## WILDWOOD

### PRIMER – Version #2

Prepared by the Department of Planning  
for the  
PLANNING AND ZONING COMMISSION  
January 19, 2016 Executive Meeting  
“Planning Tomorrow Today”

**P.Z. 1 and 1a-99 W.J. Byrne Builders, Inc., 3112 Shady Glen Estates Drive, Wildwood, Missouri 63038** - A request to amend existing Planned Residential Development Overlay District Ordinance #1189 to accommodate changes associated with a redesign of this residential subdivision that was originally approved for twenty-three (23) total units, on individual lots, to be located on a 18.33 acre tract of land, which is located on the north side of Strecker Road, east of Englebrook Drive (Locator Numbers 22U240024, 22U330031, and 22U330062 /Street Addresses 177 Strecker Road, 165 Strecker Road, and 173 Strecker Road). The modifications reflect changes to the site due to environmental considerations relating to contaminants left in place and an associated restrictive covenant approved and signed between the property owner and the United States Environmental Protection Agency (EPA), which has necessitated changes to its previously approved design. **(Ward Two)**

**Figure 2  
Removal Activity Map**

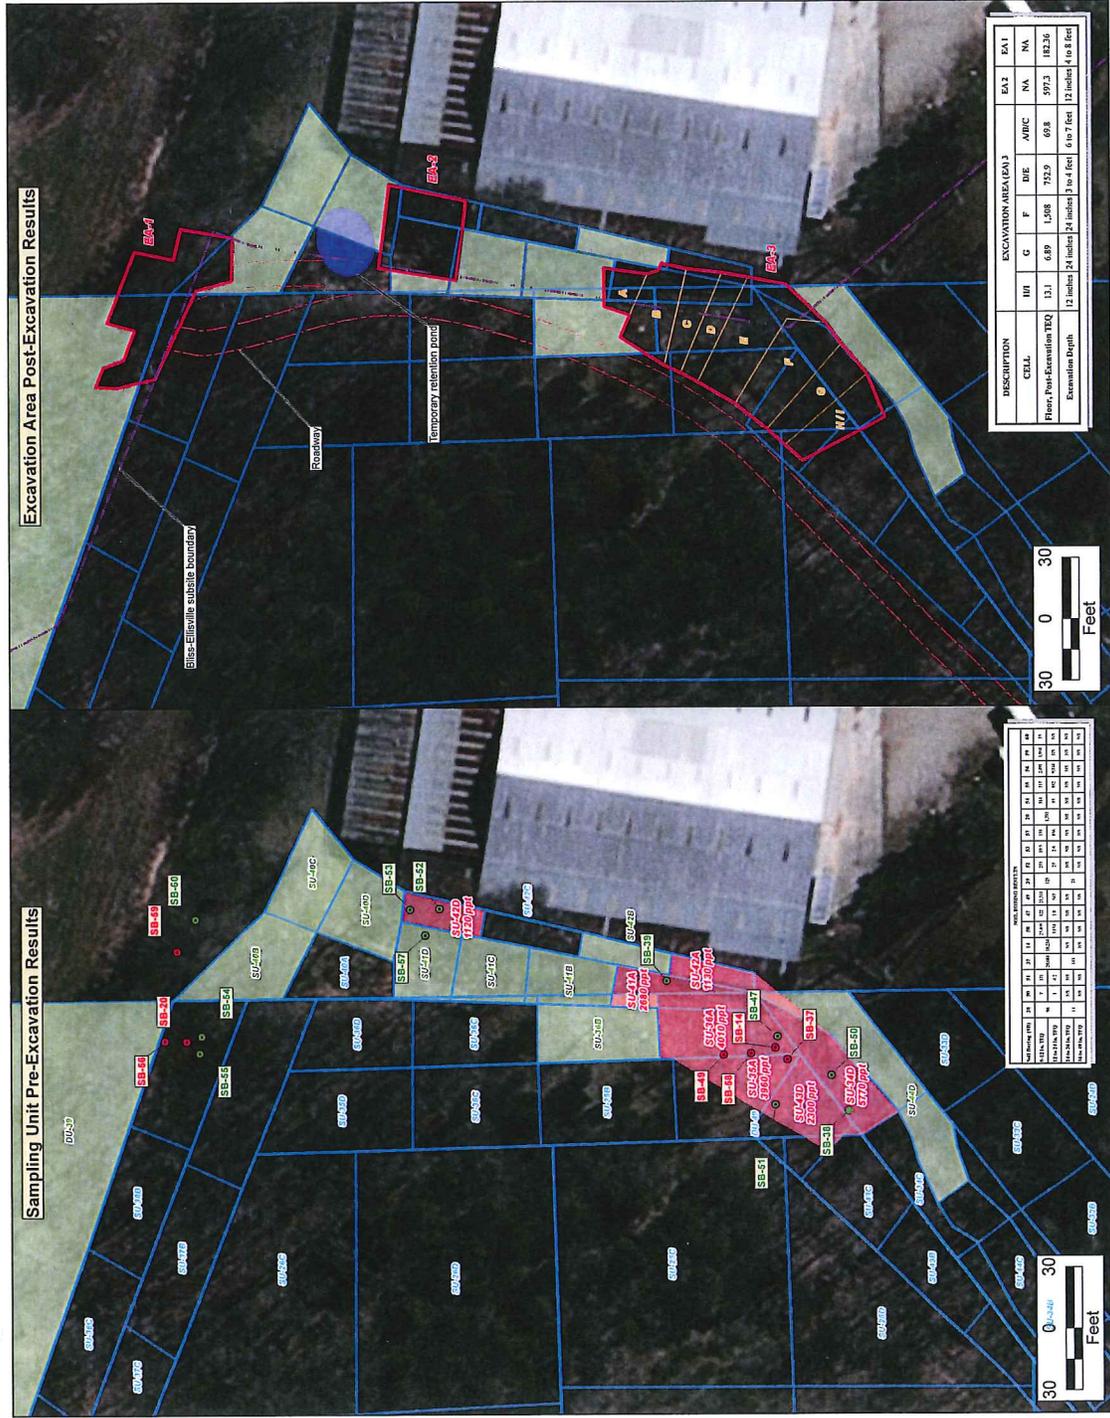
- g. **Fig. 2 Pre-Excavation**  
i. **Please add a triangle illustrating EA-1.**  
ii. **Soil Boring table is illegible.**

- g. Fig. 2 Pre-Excavation
    - i. Please add a triangle illustrating EA-1.
    - ii. Soil Boring table is illegible.
  - h. Fig. 2 Post-Excavation
    - i. Please illustrate NPL line in bright color.

A revised Removal Action Report is now available on the EPA's Region 7 website: see "Strecker Forest Environmental Review" tab on the EPA Region 7 main page. The polygon illustrating EA-1 is indicated on the post-excavation area of the figure. The soil boring table can be magnified in adobe acrobat.

**Figure 3**  
Exploratory Sampling Locations

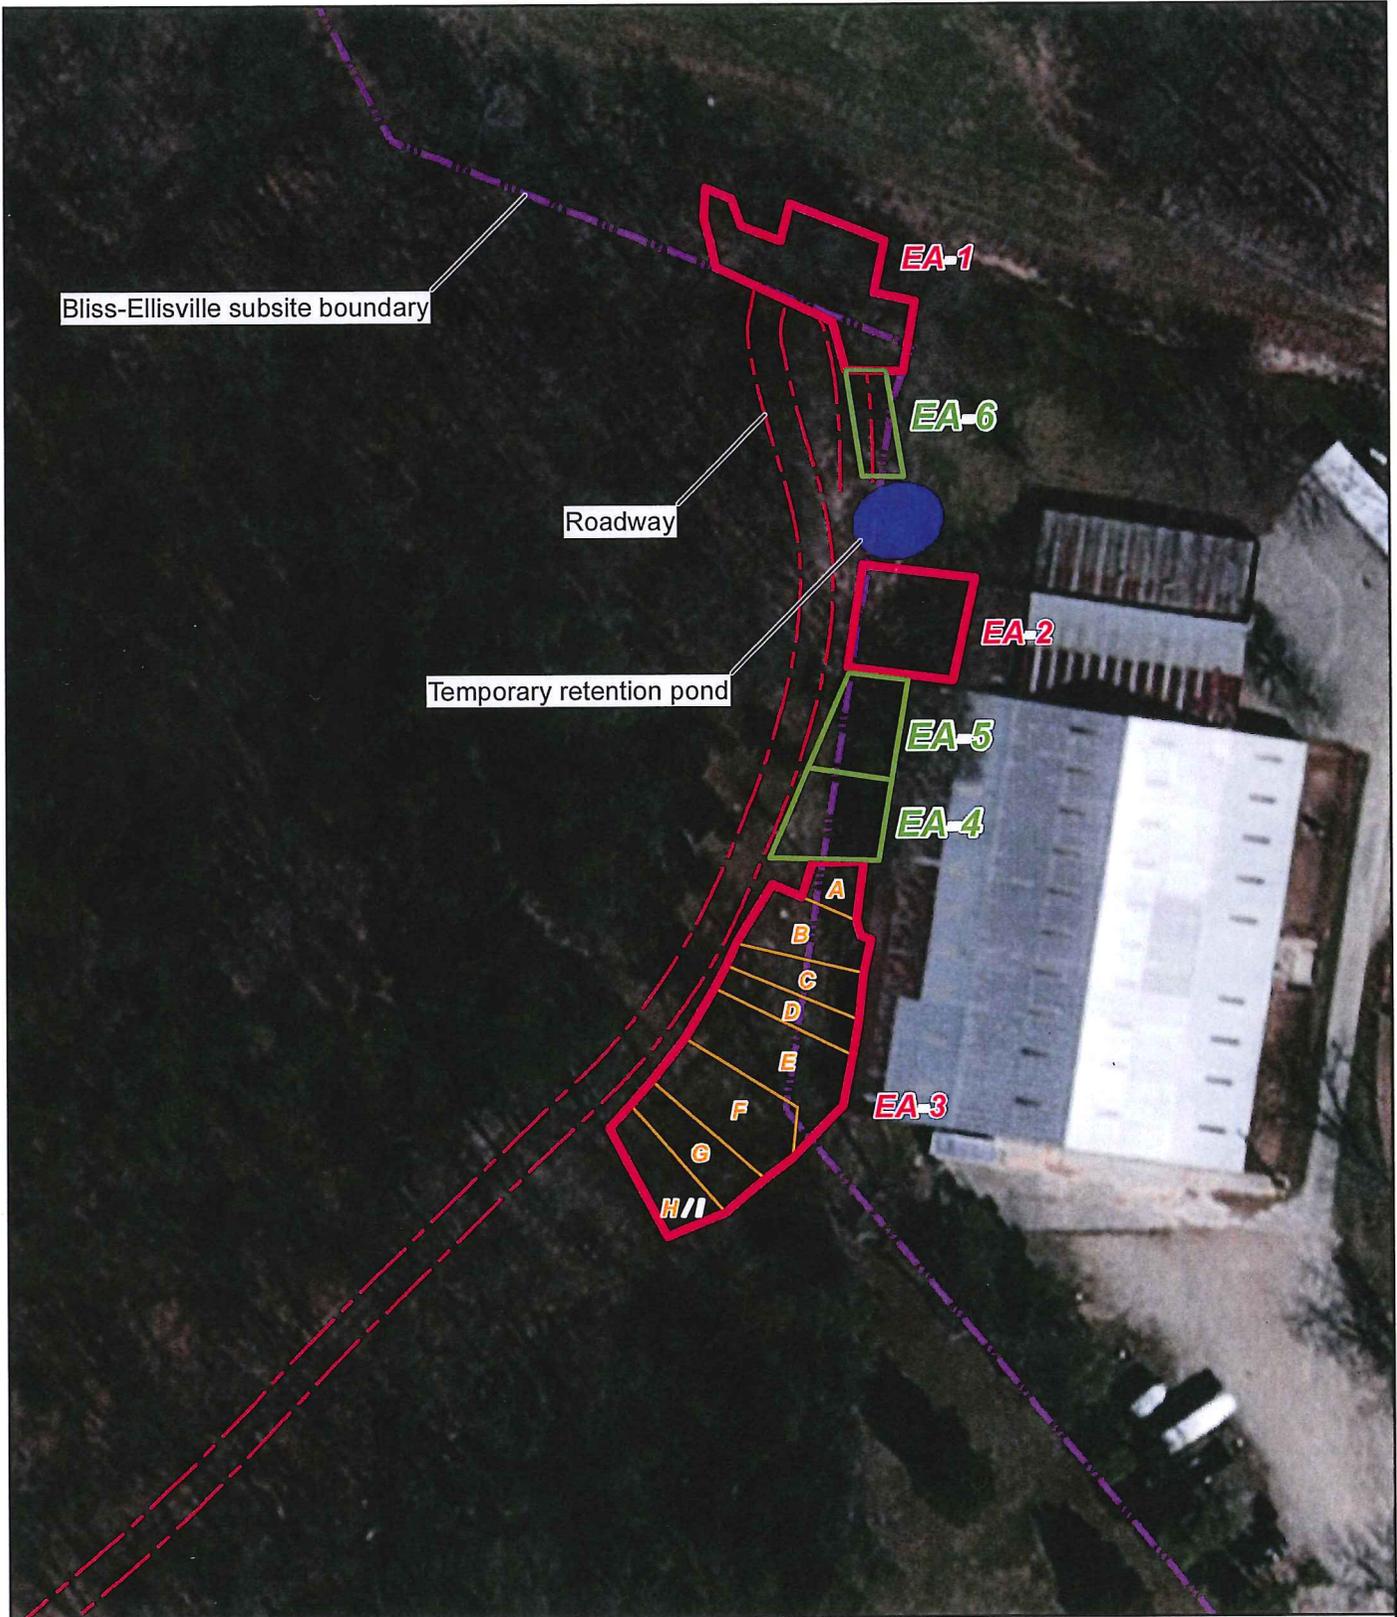
- i. Please illustrate NPL line in bright color.**
- ii. Please add the 4 cell letters to EA-2.**
- iii. Please clarify EA-1.**
- iv. Please add all property lines.**

- ii. Please add the 4 cell letters to EA-2.
    - iii. Please clarify EA-1.
    - iv. Please add all property lines.
7. Please provide the original application to the Superfund for the Bliss/Ellisville Site.

The NPL boundary is indicated in Figure 3, and in other reports, including the 2012 "Site Reassessment Report for an Expanded Site Review." EA-2 was not separated into smaller cells during the removal action; it was considered one cell/area during the removal action. Additional clarifications to EA-1 can be found in the main text, including Table 3. The 2012 Site Reassessment Report includes an overall estimation of property lines.
